Rezoning Transportation Analysis

Petition Number: 2025-137

Date	Description
4-23-26	First Review (NK)

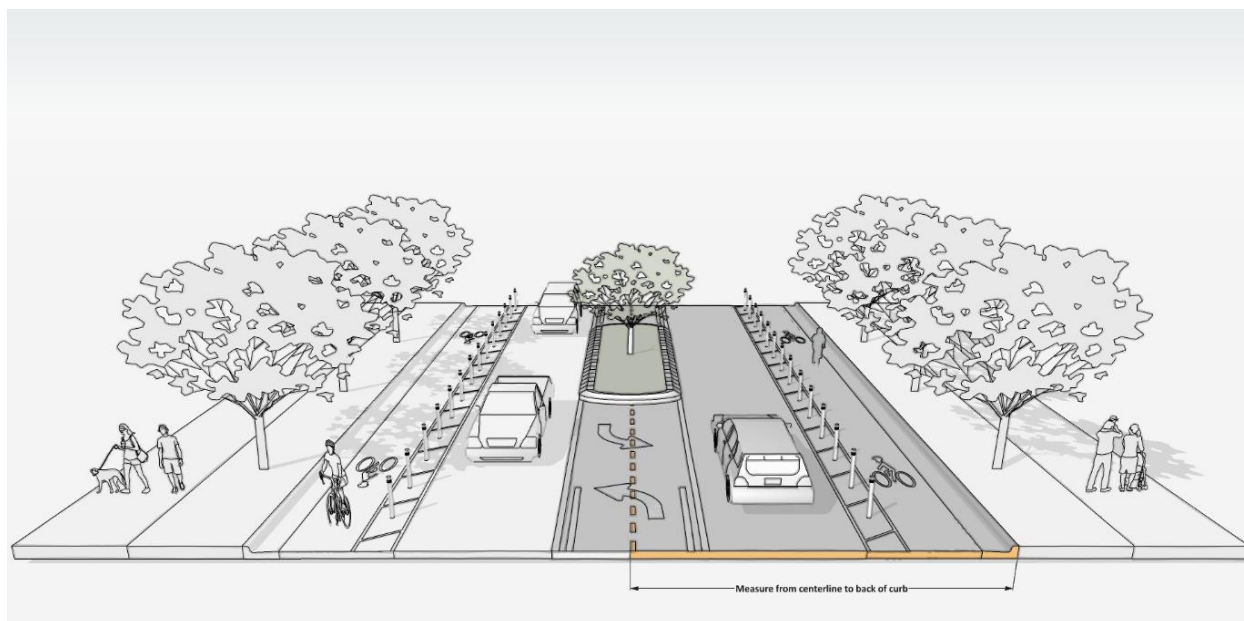
1. Curbline:

- Sharon View Road:** Location of future back of curb and gutter is 27-feet from road centerline and must be moved to the future location of back of curb. 27-feet includes a through lane, a buffered bike lane and half of the two way left turn lane (center lane) and curb and gutter. This does not include additional turn lanes and intersection geometry.

Label and dimension the curb and gutter from the centerline for each road on the site plan.

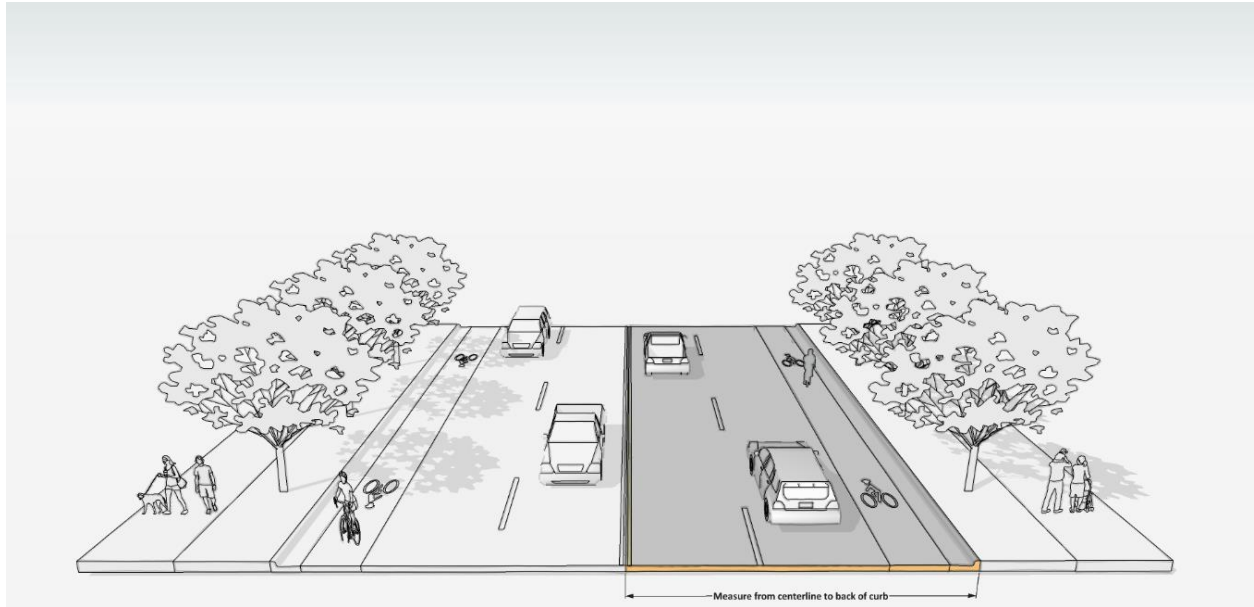
- b. **Colony Road:** Location of future back of curb and gutter is 29.5' from road centerline and must be moved to the future location of back of curb. 29.5-feet includes 2-through lanes, a bike lane and curb and gutter. This does not include additional turn lanes and intersection geometry.

Label and dimension the curb and gutter from the centerline for each road on the site plan.
